**MONTICELLO NUCLEAR GENERATING PLANT**  
Docket No. 50-263 License No. DPR-22

**Response to Request For Additional Information Related to Relief Request No. 16  
For the Third 10-Year Inservice Inspection Interval (TAC No. MB5487)**

**RESPONSE TO THE**  
**REQUEST FOR ADDITIONAL INFORMATION**  
**RELATED TO RELIEF REQUEST No. 16**  
**FOR THE THIRD 10-YEAR INSERVICE INSPECTION INTERVAL**  
**FOR**  
**NUCLEAR MANAGEMENT COMPANY, LLC**  
**MONTICELLO NUCLEAR GENERATING PLANT**  
**DOCKET NUMBER 50-263**

SUPPLEMENTAL INFORMATION IN SUPPORT OF  
REPORT 20014312  
WELD VCBB-1  
LIMITED EXAMINATION  
(1/2 SCALE)

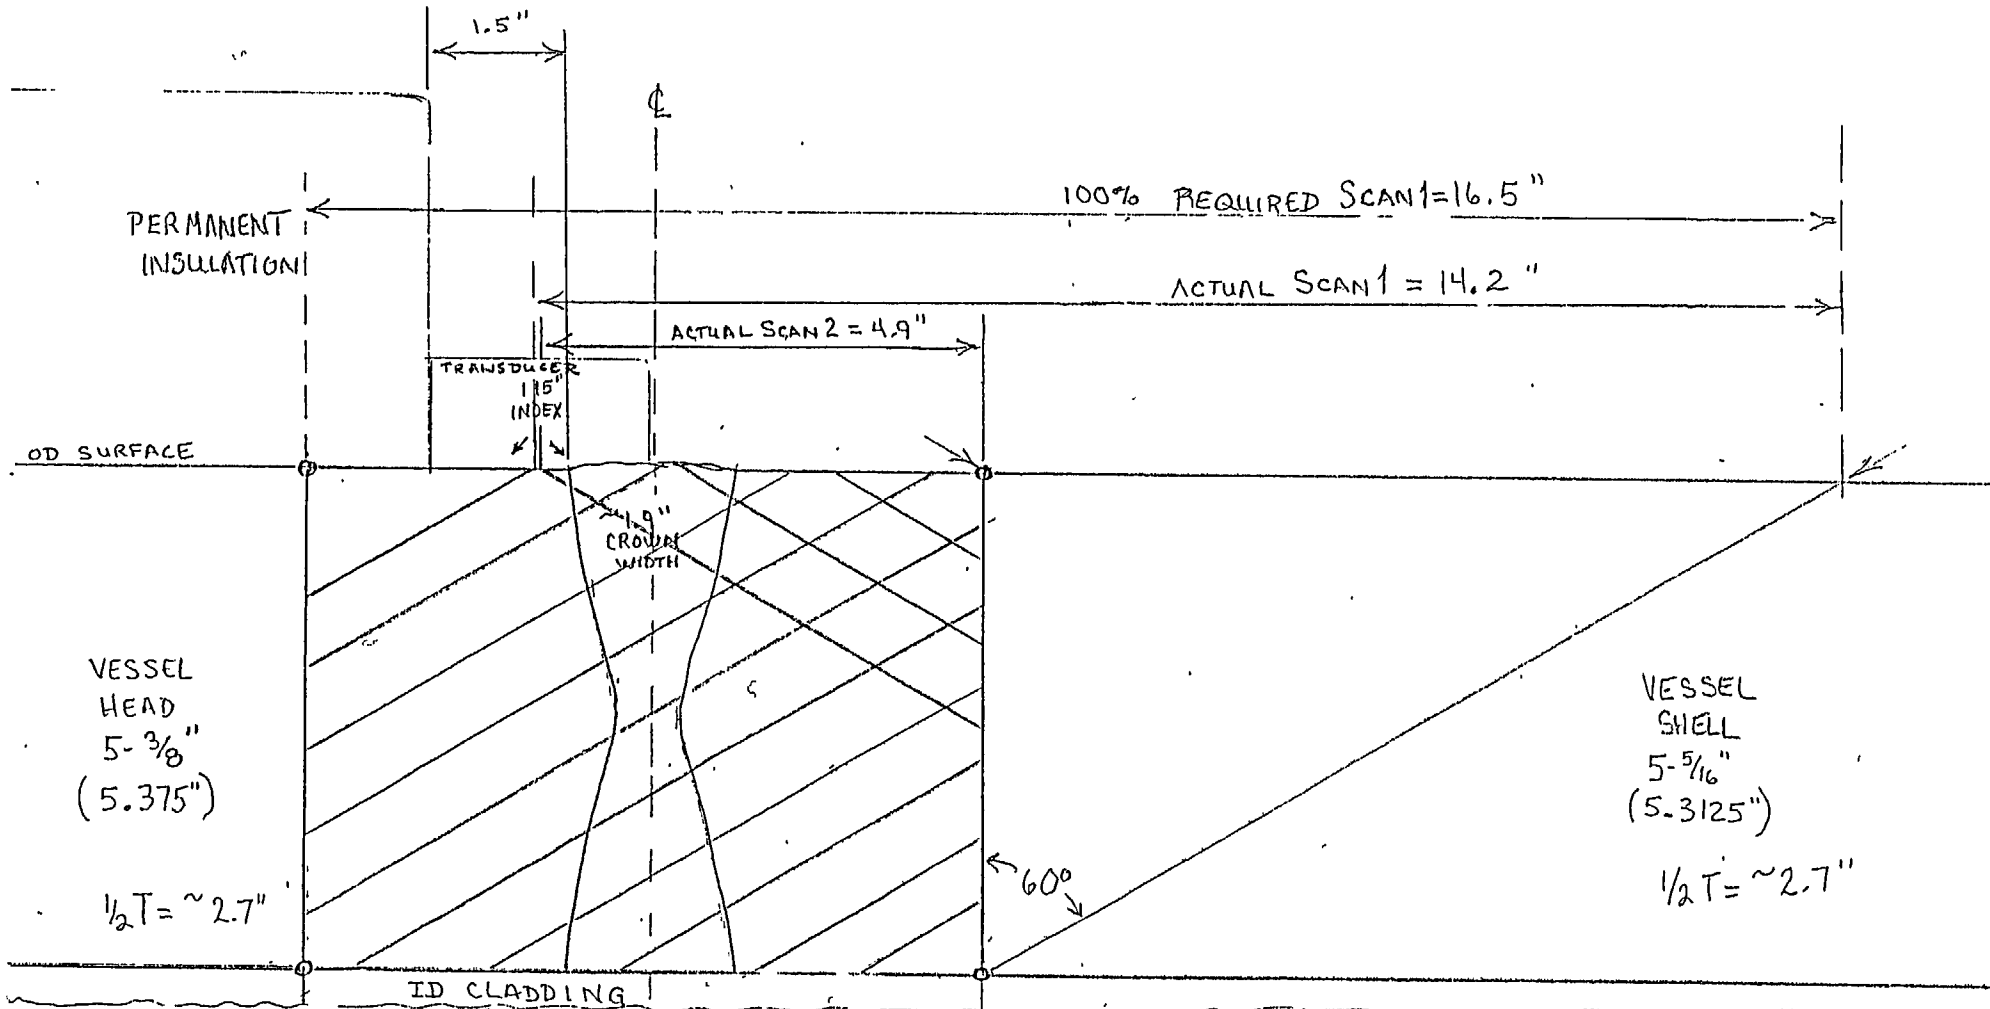
The licensee states that examination coverage was limited to scans from one side of the weld only (in the area of the weld made accessible by removal of insulation in the nozzle N1B window). Also, it appears from the limitation report 102638 that only a 60 degree examination was performed. Please clarify whether this included both refracted longitudinal and shear wave examinations, and if only the 60 degree examination was applied.

2.2.a. **NRC Question / Request:** Please clarify whether this included both refracted longitudinal and shear wave examinations, and if only the 60 degree examination was applied.

**NMC Response** As noted in ISI Report 2001U312 for Summary No.102638 which was included as Attachment 1 in the previous submittal package for Relief Request No 16 for the Third ISI Interval dated May 30, 2002 (hereafter referred to as "Original Submittal"), the primary angle applied to examination of VCBB-1 was 60 degrees and the primary mode of propagation, as specified by qualified examination procedure ISI-UT-3B, was a refracted longitudinal (RL) wave. A characteristic of the 60 degree RL transducer required for this procedure, is that it also produces a 28 degree shear wave that can be used for confirmation of indications.

A cross-sectional plot of the weld and examination area is attached to this Request For Additional Information (RAI) Response as Attachment 1. For scans perpendicular to the weld, this plot shows the beam propagation in relation to the weld and the physical obstruction created by the permanent insulation.

SUPPLEMENTAL INFORMATION IN SUPPORT OF  
REPORTS 2001VE301 AND 2001VE302  
WELDS VLA-1 AND VLA-2  
SKETCH SHOWING 100% COVERAGE

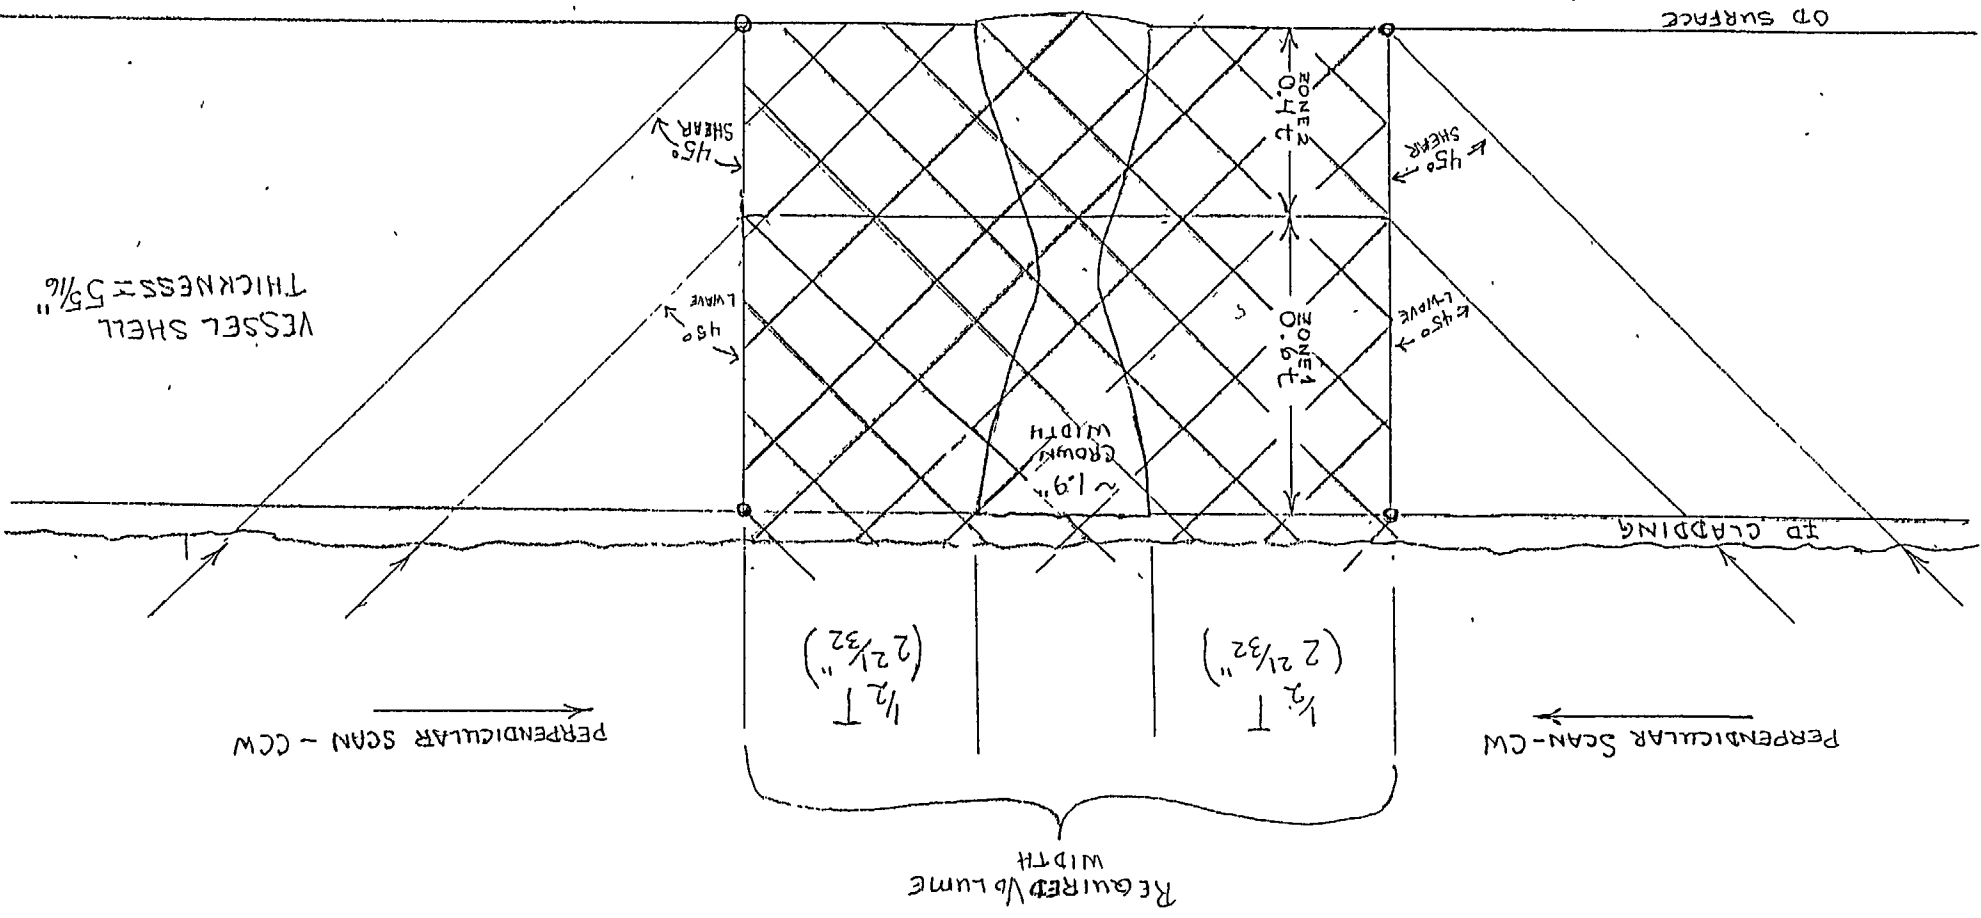
2.3 b. **NRC Question / Request:** Please confirm, through cross-sectional drawings or further descriptions, whether the coverage obtained was 100% of the Code-required volume for 80.1% and 75.8% of the length of these longitudinal welds, or whether the coverage was 80.1% and 75.8% of the volume for 100% of the weld length. Please state what cross-sections of the Code-required volume have been completed

The sketch in Attachment 5 shows the cross-section of an exam with no physical scanner limitations which provides 100% coverage of the exam volume. The sketch in Attachment 6 shows an example of exam volume coverage obtained if a physical obstruction was encountered in a symmetrical fashion, equidistant on each side of the weld centerline, e.g. partial obstruction encountered with Jet Pump Diffusers prior to complete obstruction. The limitation would impact both the 0.6t and 0.4t zones for the perpendicular scans.

Enhanced sketches for ISI Report 2001U321,  
Tee-to-Pipe Configuration

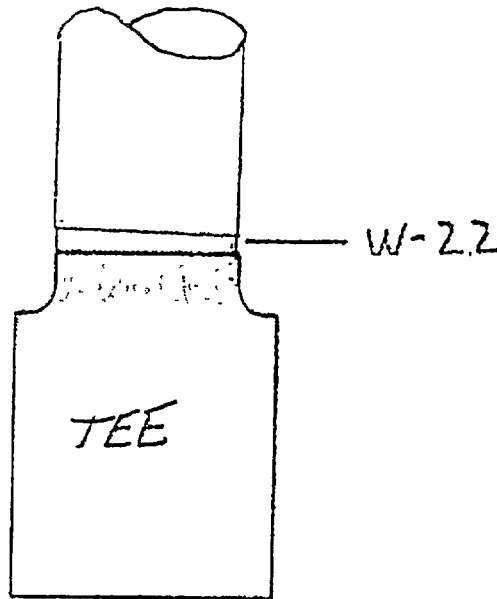
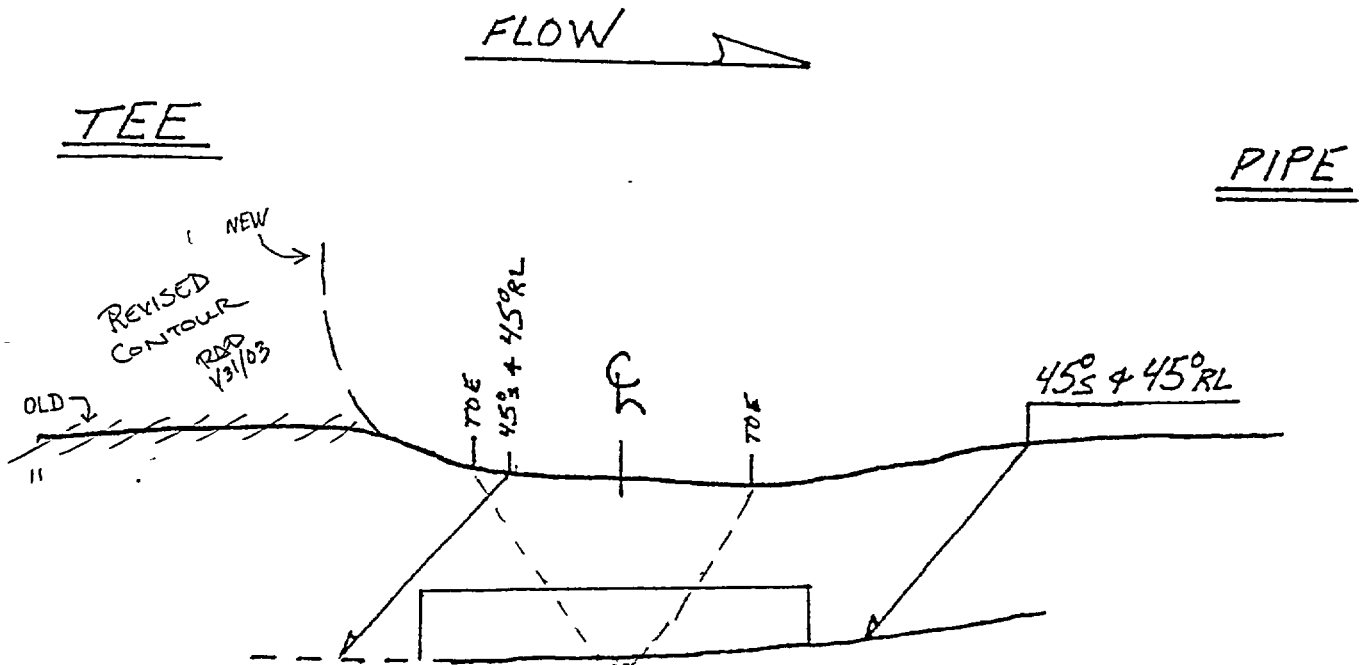
The licensee states that this weld, due to the piping-to-tee configuration, is available for UT scans from only the pipe side of the weld. However, the drawings supplied as part of limitation report 2001U321 do not adequately show this limitation. From these drawings, it appears that some access, albeit limited, may be possible from the tee side, and over the weld crown, for Scans 2, 3, and 4. Please clarify this discrepancy or further describe the scanning limitations. Also state if other B-J weld configurations are being examined to the full extent required by Code.

2.4.a **NRC Question / Request:** From these drawings, it appears that some access, albeit limited, may be possible from the tee side, and over the weld crown, for Scans 2, 3, and 4. Please clarify this discrepancy or further describe the scanning limitations.

**NMC Response:** The sketch provided by the UT examiner in Report 2001U321, Attachment 2 in the Original Submittal, does not fully depict the surface profile for actual tee-to-pipe configuration. Based on the Section XI Coordinator's recollection, the examiner verbally indicated that the radius of the tee was very close to the weld zone, and did not permit the transducer shoe to maintain adequate contact with the tee. Also, with the change in surface profile, the examiner would be unsure of where the sound beam was traveling. It was also noted on the report that this examination is performed in a 300 millirem/hour dose area.

The tee in this weld configuration is a 22 x 22 x 12 inch reducing tee. The examination was being performed from the side of the 12 inch Recirculation Riser. The weld number found on the report says W-22 (LSUD) (LSUD stands for Longitudinal Seam Upstream and Downstream). Sketches for Report 2001U321, included in the Original Submittal, have been enhanced to more accurately depict the configuration, and these enhanced sketches are included in this RAI Response as Attachment 7 (2 pages). Also included in this RAI Response as Attachment 8 is a spool piece drawing from Texas Pipe Bending Company which was provided at the time of the Recirculation System Piping Replacement Project in 1984. It more clearly shows what the examiner has described with regards to the proximity of the weld to the tee radius. The overhead view, which provides a relational view of the 22 inch to 12 inch pipe reduction, shows that the physically limiting condition of the tee radius described by the examiner would remain essentially constant for the entire circumference of the 12 inch weld, W-22 (LSUD).
